Liberty School District – Storm Shelter Additions
Addendum No: 005
Description Narrative
October 06, 2023

Revised architectural sheets G102, A101A, A121A, A141, A332, A662

Wall Section - Area A - Connection - E

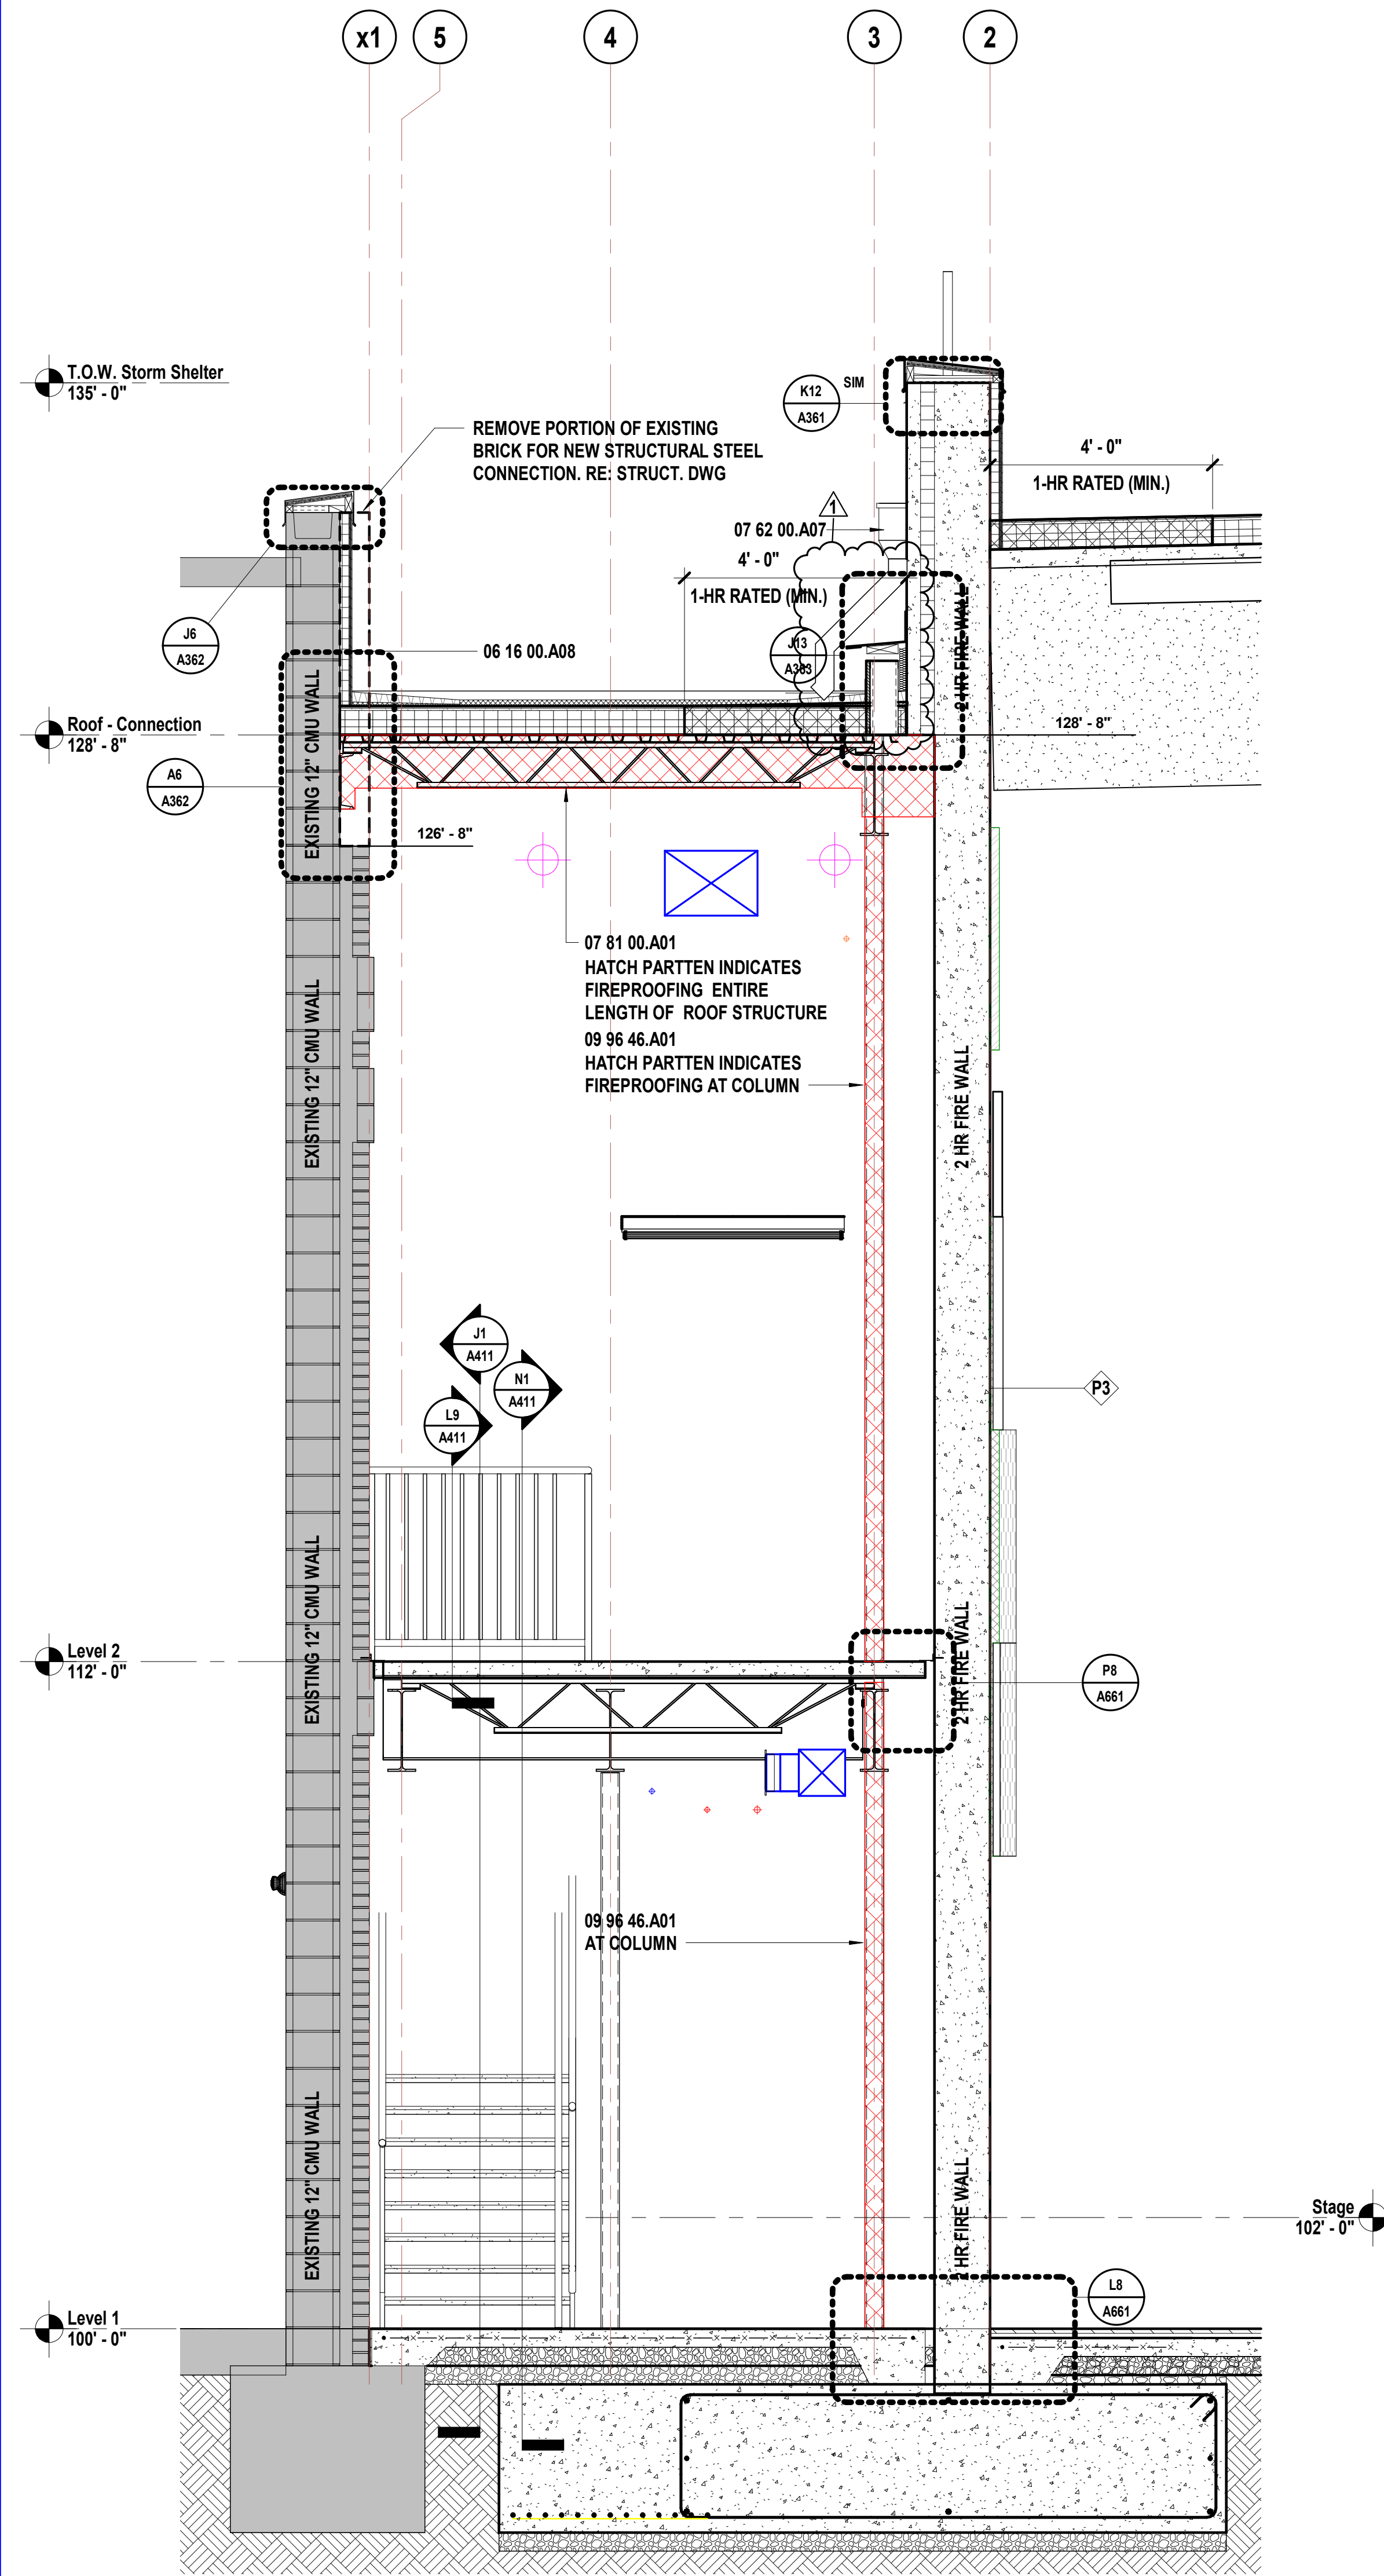
A16.2 REVISED wall section A7, per Sheet A332.

ME212A

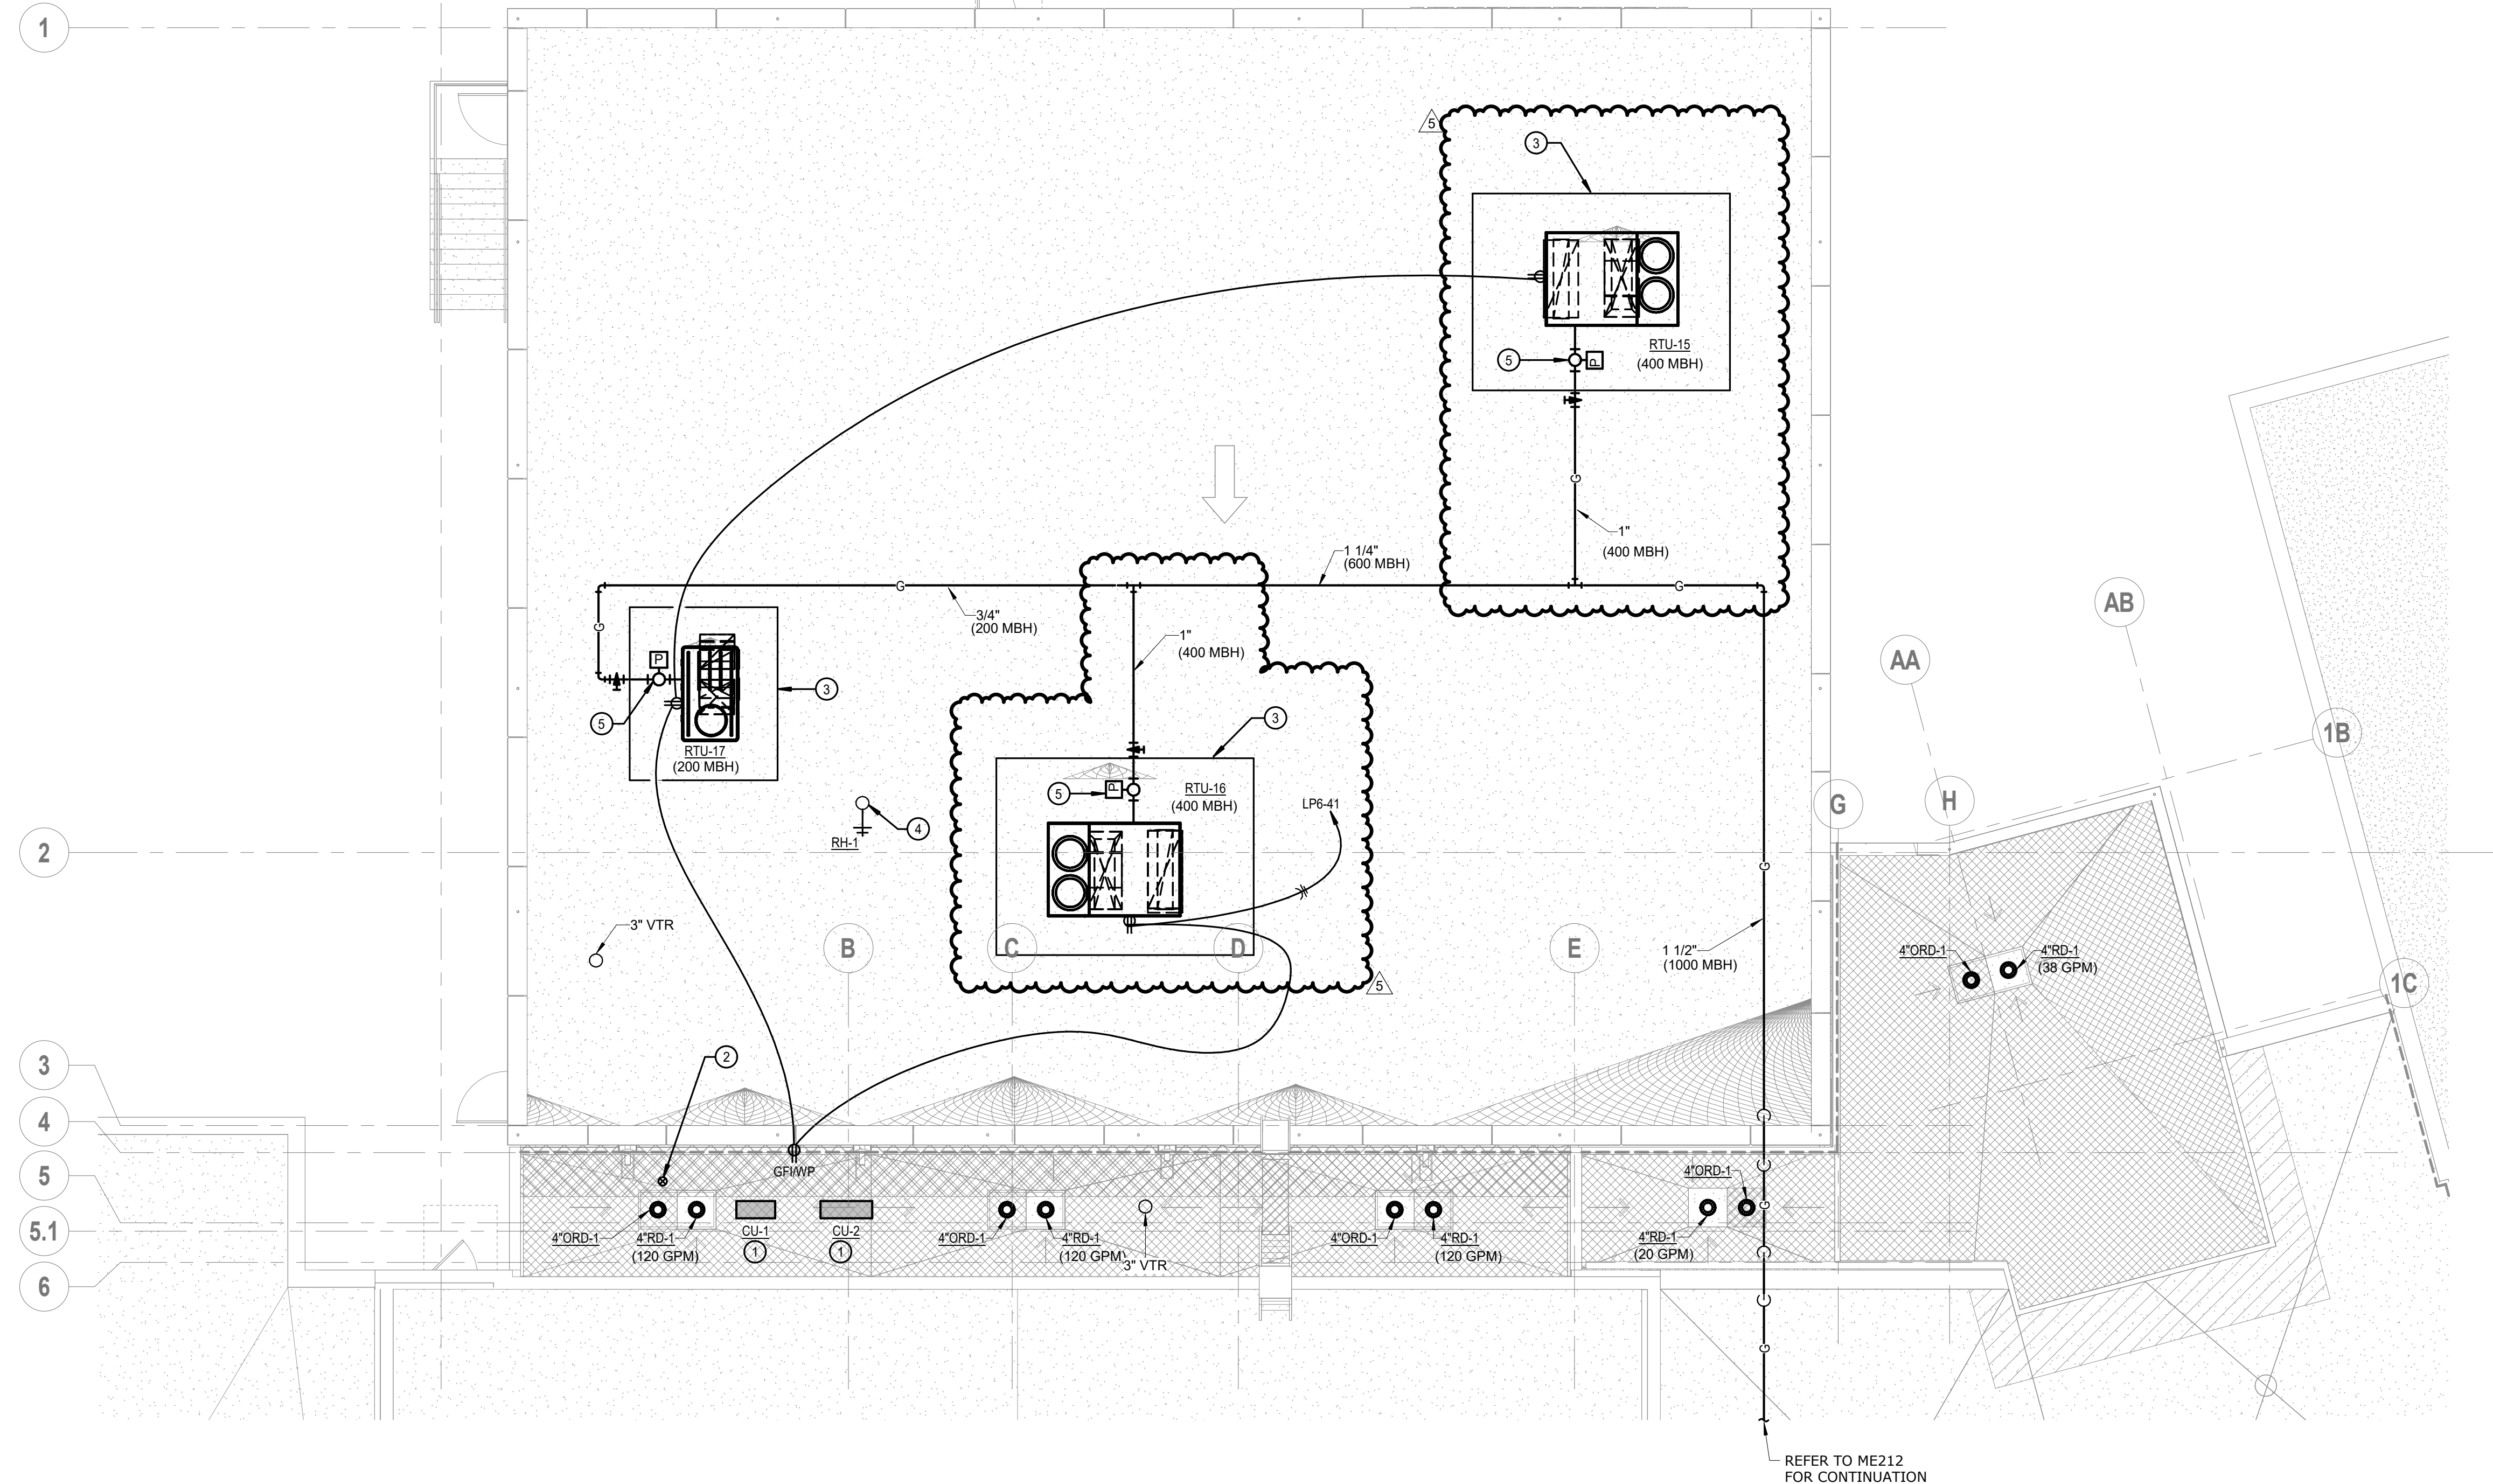
1. Sheet ME212A – Mechanical and Electrical Roof Plan – Area A
 - a. Rotate RTU-15 and adjust associated power and gas piping.
 - b. Rotate RTU-16 and adjust associated power and gas piping.

ME301

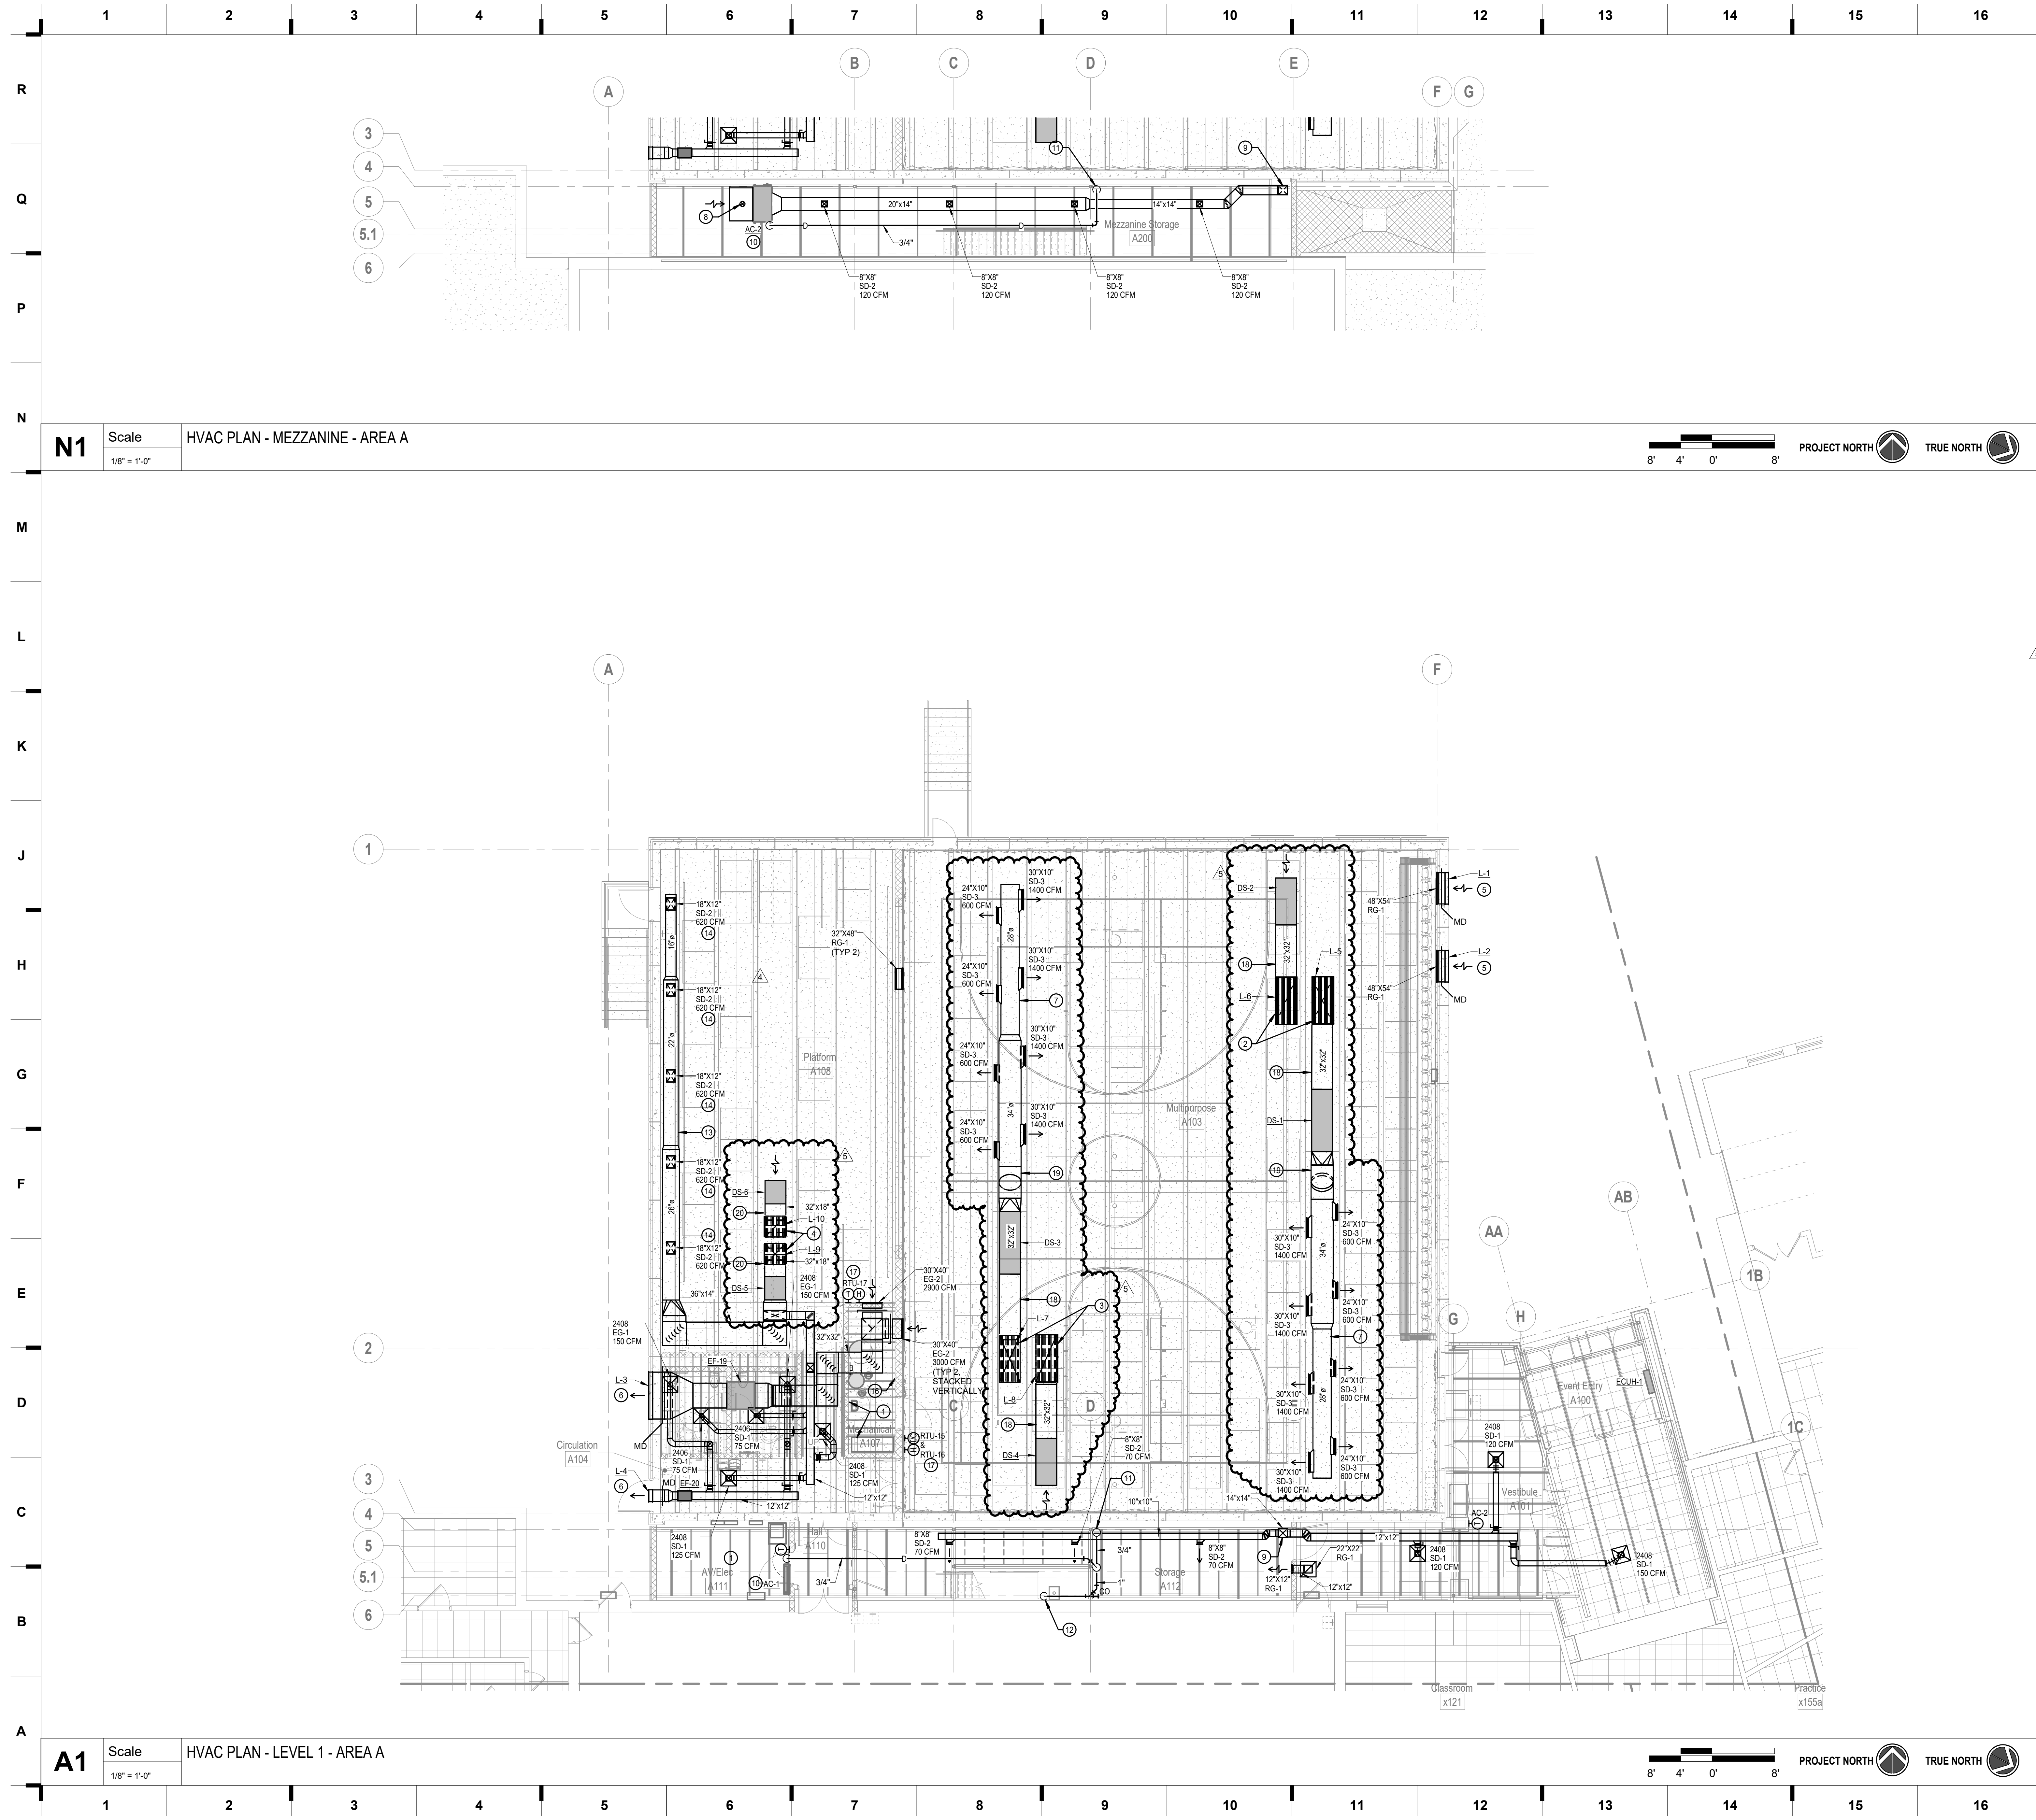
2. Sheet ME301 – Mechanical and Electrical Schedules
 - a. Remove the combined ductwork and insulation schedule.
 - b. Add Ductwork Schedule.
 - c. Add Ductwork Insulation Schedule.

- d. Add L-5 through L-6 to the Louver Schedule.
3. Sheet M101A – HVAC Plan – Level 1 & Mezzanine – Area A
 - a. Revise plan notes 2, 3, and 4.
 - b. Remove shrouds and replace with ICC 500 rated louvers at rooftop unit duct penetrations and revise associated ductwork.
